SUBJECT: ST. LUCIE UNIT 1 - ISSUANCE OF AMENDMENT RE: AXIAL SHAPE INDEX
LIMITS (TAC NO. 76173)

AMENDMENT NO. 106 TO FACILITY OPERATING LICENSE NO. DPR-67 - ST. LUCIE, UNIT 1

ATTACHMENT TO LICENSE AMENDMENT NO. 106
TO FACILITY OPERATING LICENSE NO. DPR-67
DOCKET NO. 50-335

SAFETY EVALUATION BY THE OFFICE OF NUCLEAR REACTOR REGULATION

FIGURE 2.2-2

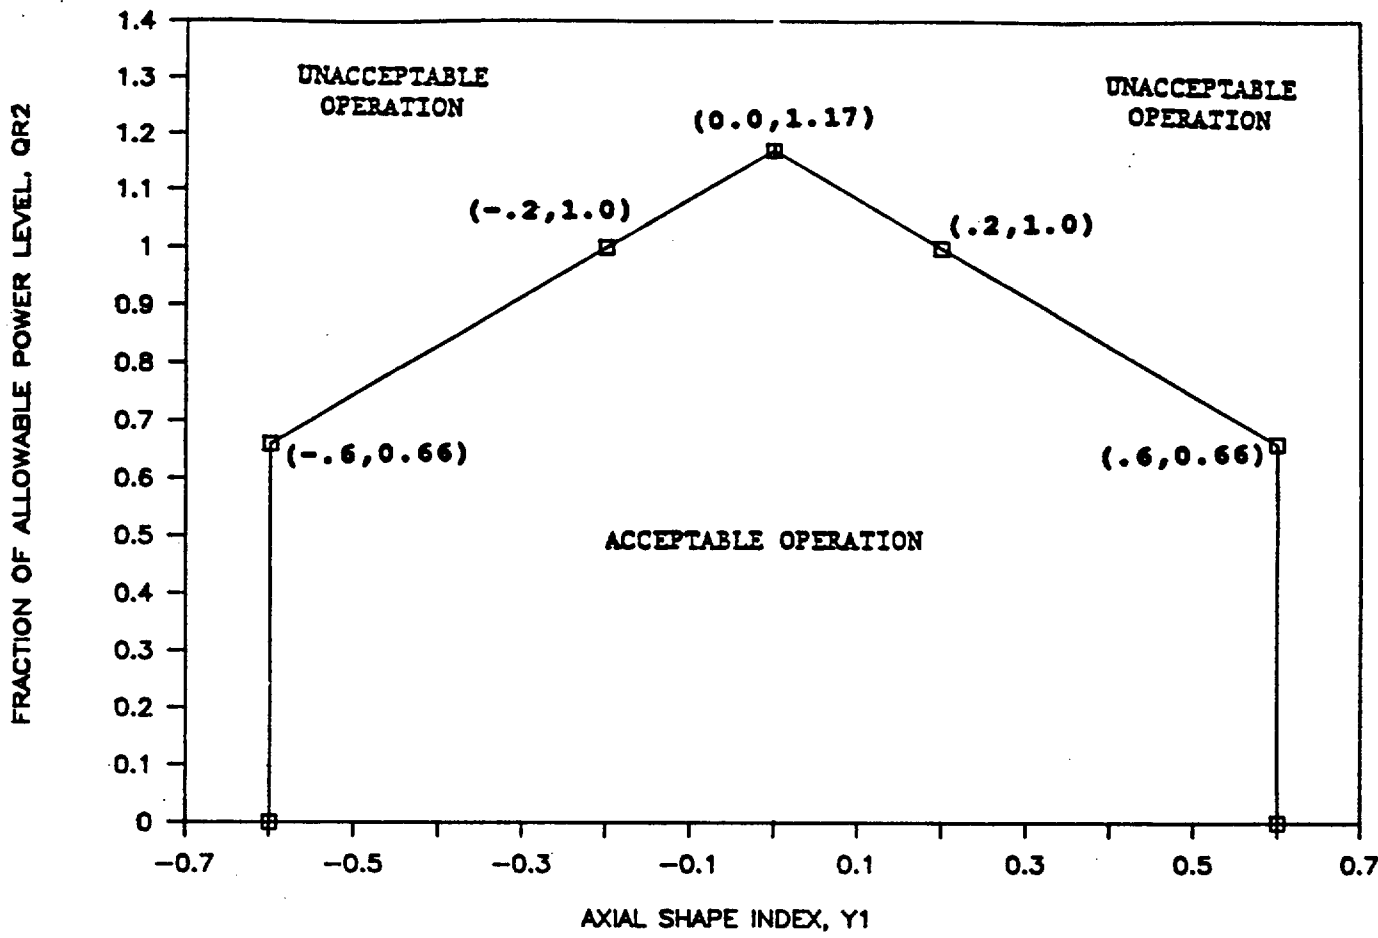
This amendment provides greater operational flexibility at lower power by expanding the Axial Shape Index (ASI) limits for the Departure from Nucleate Boiling (DNB) and Local Power Density (LPD) Limiting Conditions for Operation (LCOs) and the LPD Limiting Safety System Setpoints (LSSS) (Technical Specification Figure 2.2-2), the LPD LCO (Technical Specification Figure 3.2-2), and the DNB LCO (Technical Specification Figure 3.2-4).

By letter dated March 9, 1990, as supplemented September 24, 1990, Florida Power and Light Company (FPL) submitted proposed modifications to the St. Lucie Unit 1 Technical Specifications. Specifically, the proposed changes would modify the Local Power Density (LPD) Limiting Safety System Setpoints (LSSS) in Technical Specification Figure 2.2-2, the LPD Limiting Condition for Operation (LCO) in Technical Specification Figure 3.2-2, and the Departure from Nucleate Boiling (DNB) LCO in Technical Specification Figure 3.2-4.

To achieve greater operational flexibility at lower power, FPL has proposed to expand the LPD LSSS Axial Shape Index (ASI) limits for power levels below 66 percent Rated Thermal Power (RTP) from ± 0.4 to ± 0.6 and for 100 percent power level from $- 0.145$ to $- 0.2$. The changes would also expand the ASI limits of the LPD LCO for power levels below 45 percent RTP (but above 40 percent RTP) and the ASI limits of the DNB LCO for powers below 65 percent RTP (but above 40 percent RTP) from ± 0.3 to ± 0.5 . In addition, changes are proposed to ASI limits of the LPD LCO at 85 percent RTP from 0.02 to $- 0.08$.
